# County of Fairfax, Virginia

## STAFF REPORT

APPLICATION SE 2013-MA-010

# GLEN CARLYN CHILD CARE CENTER

FRONT YARD ANGLE OF BULK PLANE FOR THE R-3 DISTRICT (PER SECTION 3-307.2.B)

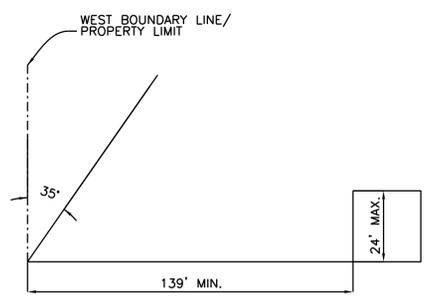
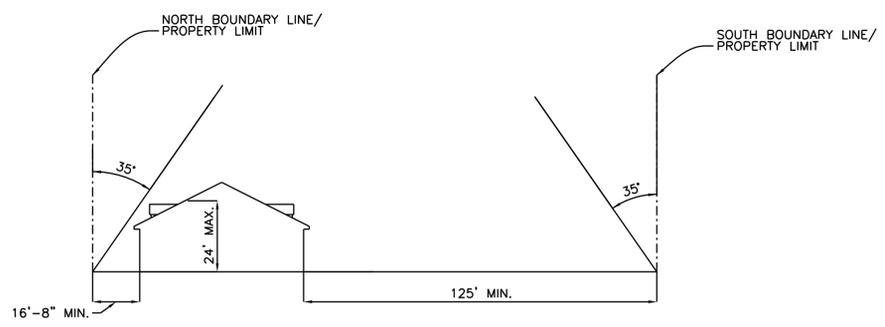
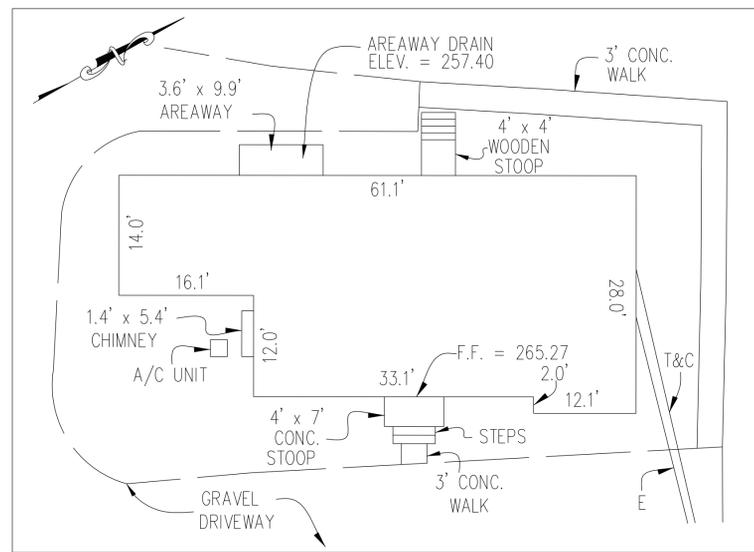
As shown in the chart above, the proposal conforms to the minimum bulk regulations for the R-3 District. The applicant has provided an angle of bulk plane analysis on Sheet 3 that shows conformance with the appropriate setback requirements based on a 24 foot tall structure.

BMP DRAINAGE AREA MAP

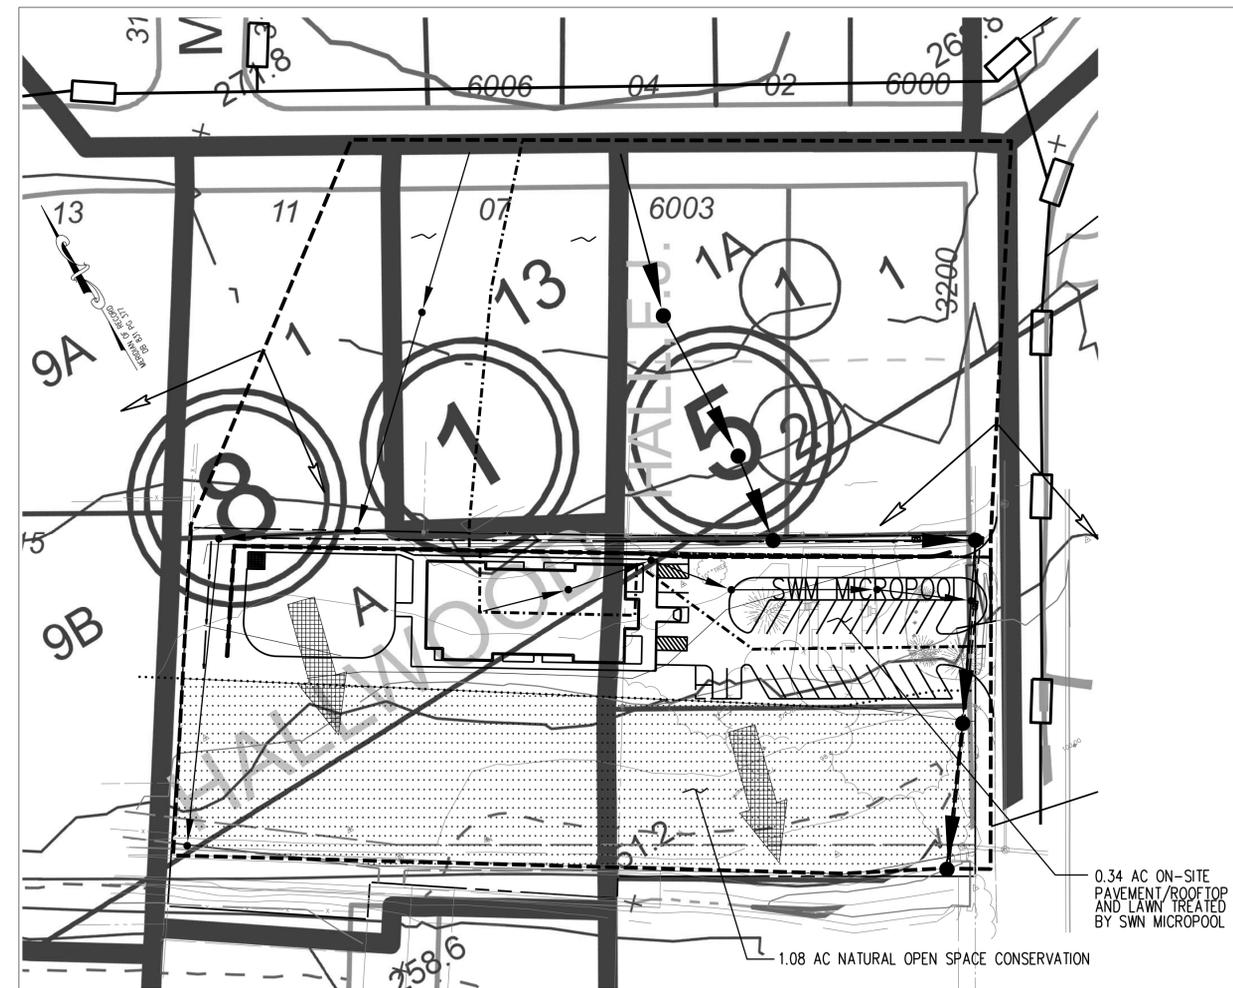
According to the applicant's adequate outfall narrative on Sheet 7 of the SE Plat, stormwater will be accommodated by an enhanced detention micro pool located in the island in the parking area. The pool will then outfall to the channelized section of the Long Branch at the southern end of the property. Post development peak flows will be

less than pre-development conditions in the two and ten year storms. The preservation of 1.08 acres of open space within the RPA area, in conjunction with the micro-pool, will be used to meet BMP requirements. Sheet 7 shows a 42% reduction in phosphorus, which exceeds the ordinance requirement for 40%. A development condition has been proposed that requires DPWES approval of the proposed stormwater management system and BMPs at the time of site plan review. After reviewing the proposal, DPWES had several additional comments related to the RPA and floodplain on the property as well as the proposed drainage divide.

**Figure 2: Site Layout**

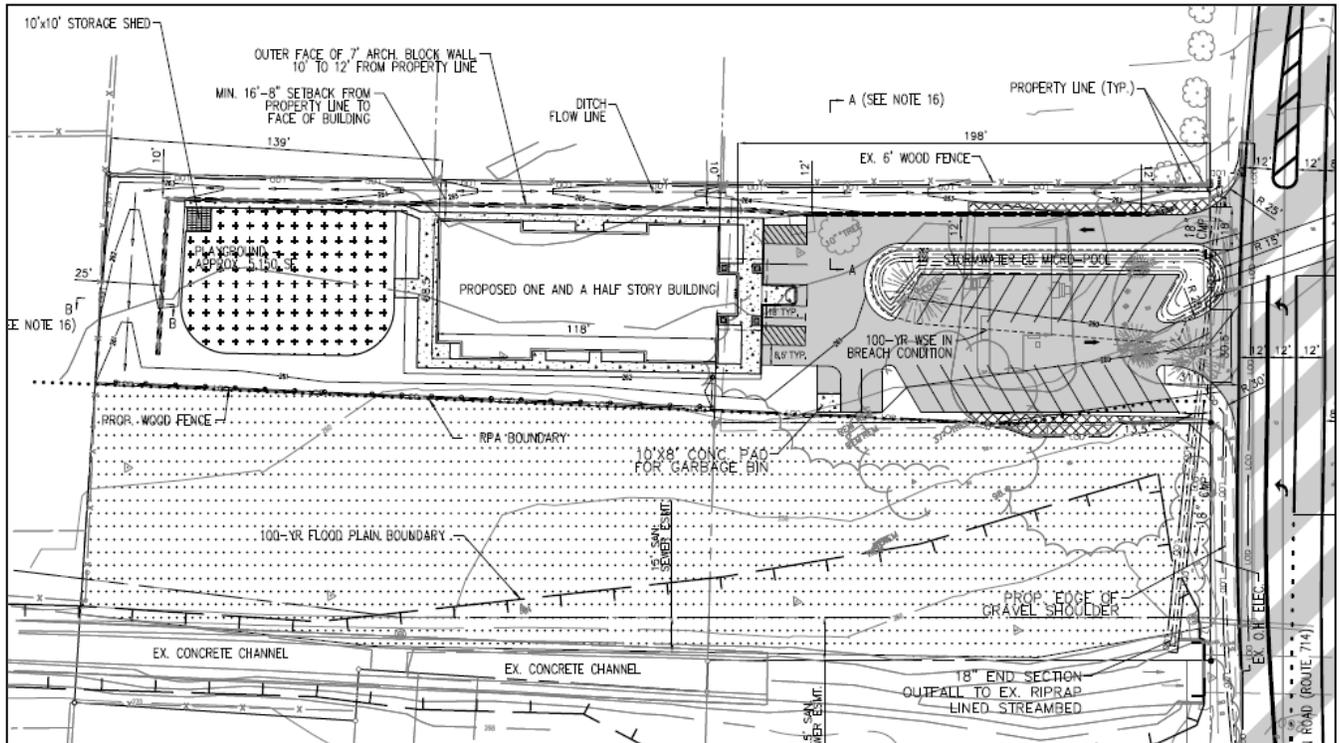
The parking tabulations on Sheet 2 of the SE Plat show that the proposal meets the ordinance requirement for child care facilities. The 99 children generate the need for 19 spaces (at 0.19 spaces/child). The applicant is proposing to provide 27 spaces in the surface parking lot at the front of the building. One loading

space has been provided towards the northeastern corner of the building; this meets the ordinance requirement.

Figure 3 – Front (top) and North (bottom) side Elevations

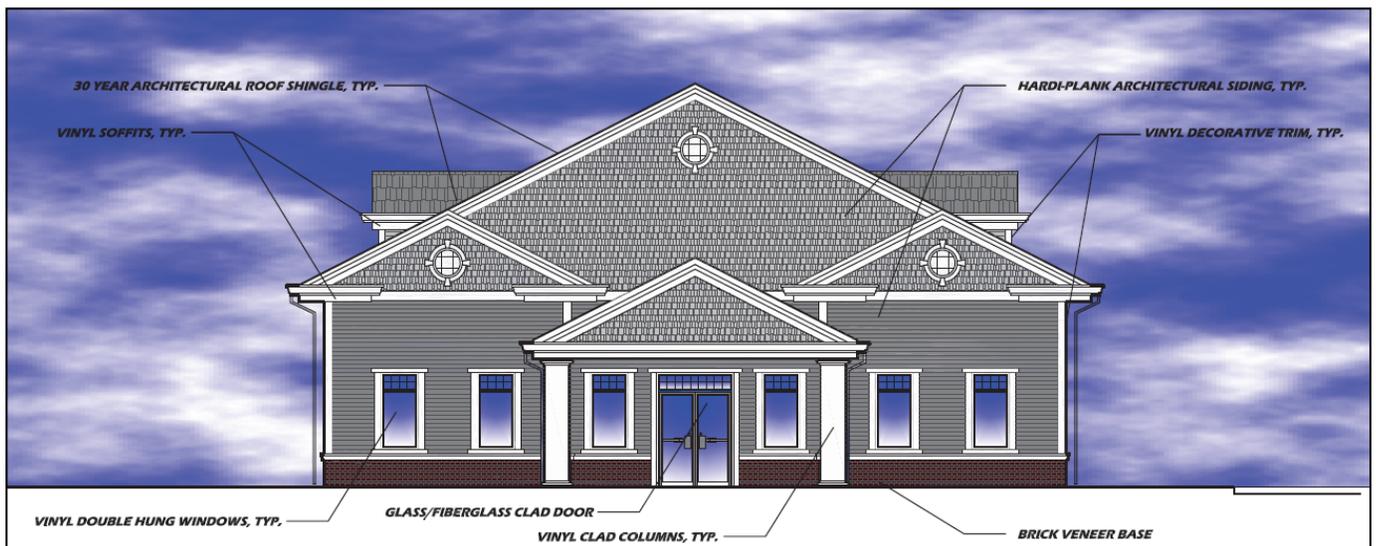
Conceptual building elevations with proposed screening have been provided on Sheet 9 of the SE Plat. More detailed elevations with building materials were submitted separately. The one and one-half story building features a colonial-style design with a gable roof and dormer windows. The structure was revised from earlier designs to reduce both its length and height and now measures 118 feet long by 58.5 feet wide, at its widest point. At staff's recommendation, the long north and south facades have been modulated and now feature a five foot deep indentation along the central portion of the building. The elevations indicate that the building's exterior will be constructed of fiber cement siding with a brick veneer base (see Figures 3 and 4).
